SI B51 20 16
Body Equipment

Door Will Not Go Up All The Way

I12 (i8)

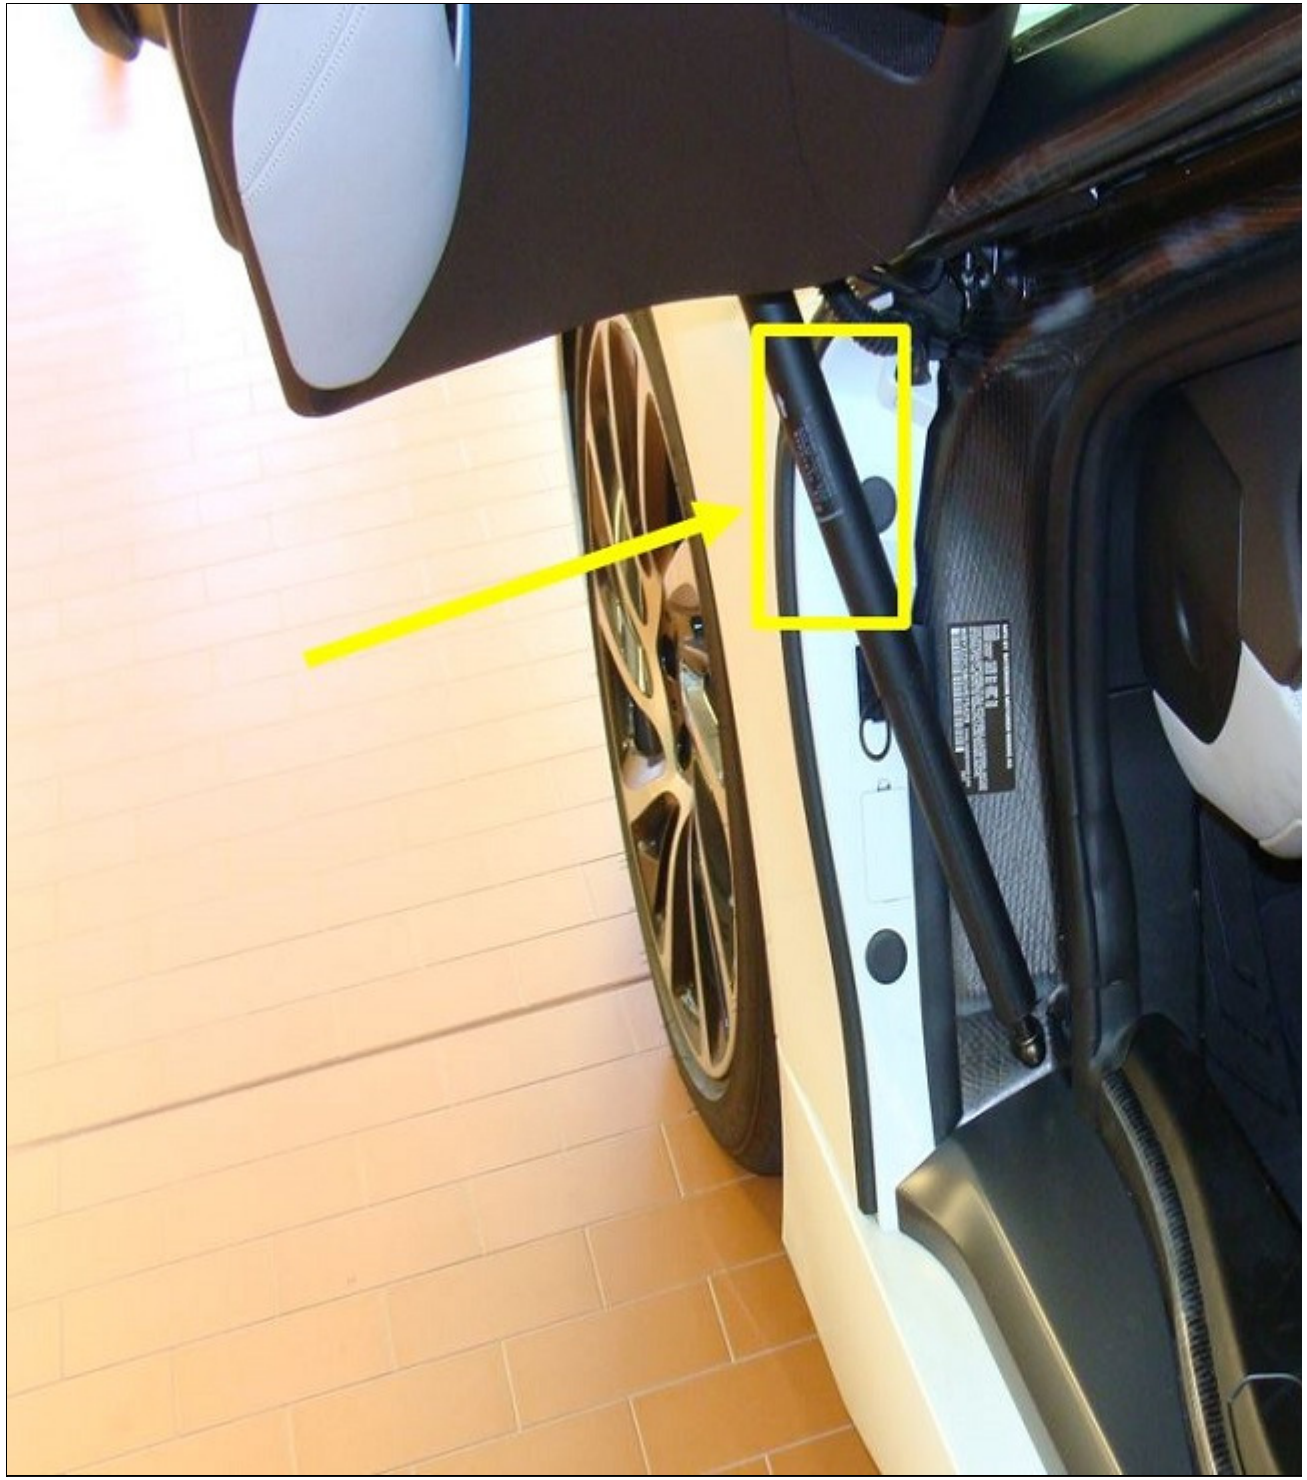
The driver's side or passenger's side door may not open to the highest position.

Insufficient lifting force from gas pressurized damper spring.

Replace gas pressurized damper spring with the next highest opening force level.

Part Number	Description	Quantity
51 22 7 375 528	Gas Pressurized Spring (plus 30N force)	1 or 2
Or:		
51 21 7 404 764	Gas Pressurized Spring (plus 60N force)	1 or 2
